SUNDRY NOTICES AND REPORTS ON WELLS

8. Well Name and No.
Plains Federal #1

9. API Well No.
30-041-20873

**Plains Federal 1
30-041-20873
John R Stearns
November 30, 2017
Conditions of Approval**

John R. Stearns
Plains Federal #1
API 30-041-20873
WBD before PA

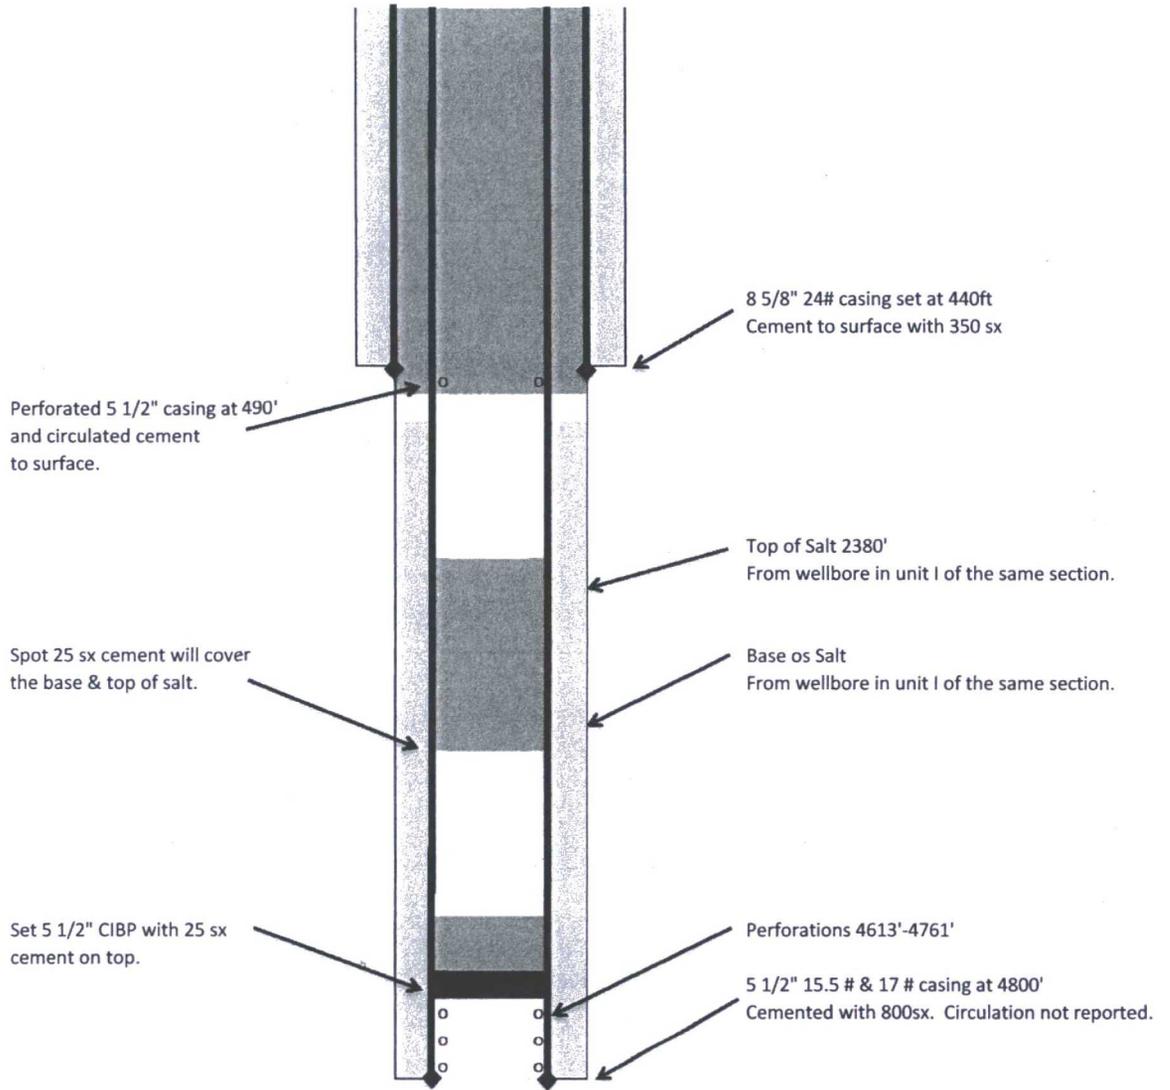
- 1. Operator shall place CIBP 50'-100' above top most perf as proposed and place 25 sx of Class C cement on top as proposed. WOC and TAG.**
- 2. Operator shall place a Class C cement plug from 2,800'-2,600' to seal the Yates formation.**
- 3. Operator shall place 25sx Class C cement at 2,485'. Tag a minimum of 2,285'.**

Note: Operator may combine plugs in step 3 and 4 to have one plug from 2,800'-2,285'. WOC and TAG.

- 4. Operator shall perf and squeeze at 490' as proposed and set a Class C cement plug from 490' - surface.**
- 5. See Attached for general plugging stipulations.**
